Park Square Apt.'s

880 Park Street

City Council Appeal Hearing
December 4, 2018

880 Park Street –Tree Protection Plan

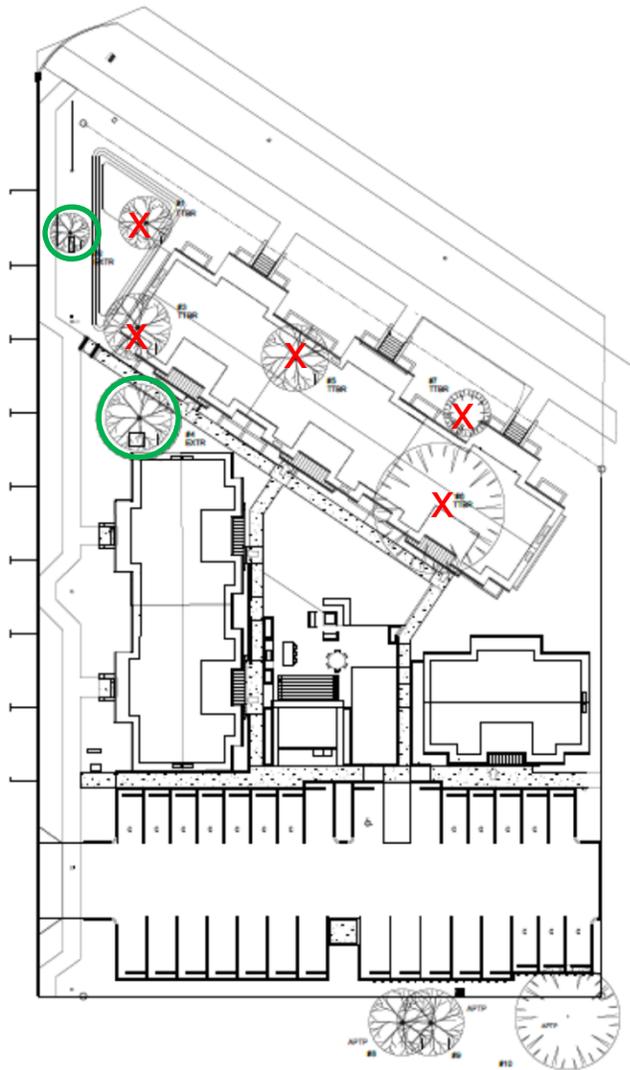
That the tree protection plan is inadequate, and that tree protection for the project site's trees and neighbor's trees should be applied equally.

- Staff recommended Condition #9e which the Planning Commission adopted requiring that the building permit submittals include, “*... a revised Tree Inventory and Tree Protection Plan be provided for the review and approval of the Staff Advisor. This plan shall identify and address protection of all trees to be preserved on the site and those on adjacent to the site within 15 feet of the property line which are six-inches in diameter at breast height or greater, and shall include a watering schedule for trees to be preserved and protected, with watering to occur at least twice per week.*”

That the tree protection plan is inadequate, and that tree protection for the project site's trees and neighbor's trees should be applied equally.

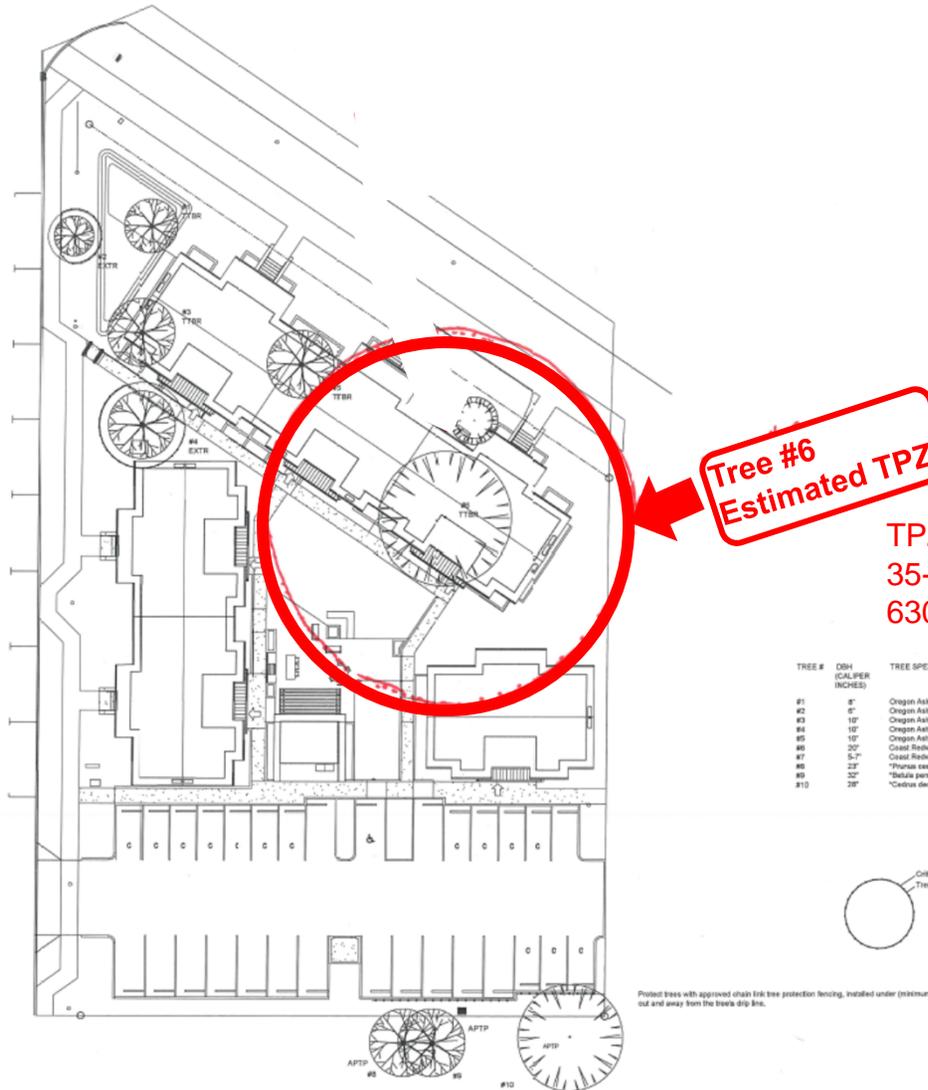
For staff, it is important to recognize that a Tree Protection Plan will consider a tree's health, potential hazards, and tolerance for the development disturbance proposed and provide recommendations to provide for the tree's preservation and protection by limiting activities within a specific protection zone. A Tree Protection Plan does not prevent all activities within the protection zones, but might call for hand excavation and hand pruning of roots or require the use of only permeable paving materials within the protection zone.

In staff's view, the applicant's own submittals recognized that the tree protection plan needed to be revised to consider the trees on neighboring properties, staff conveyed this through the hearing process, and the adopted decision includes a specific requirement that the building permit submittals include a revised Tree Protection Plan which addresses the trees on neighboring properties within 15 feet of the property line, as required by code.

Staff would recommend that the Council find that the Planning Commission's Condition #9e requires that the applicant provide a revised tree protection plan which addresses the neighbors' trees to the extent required by the Tree Preservation and Protection Ordinance (AMC 18.4.5).
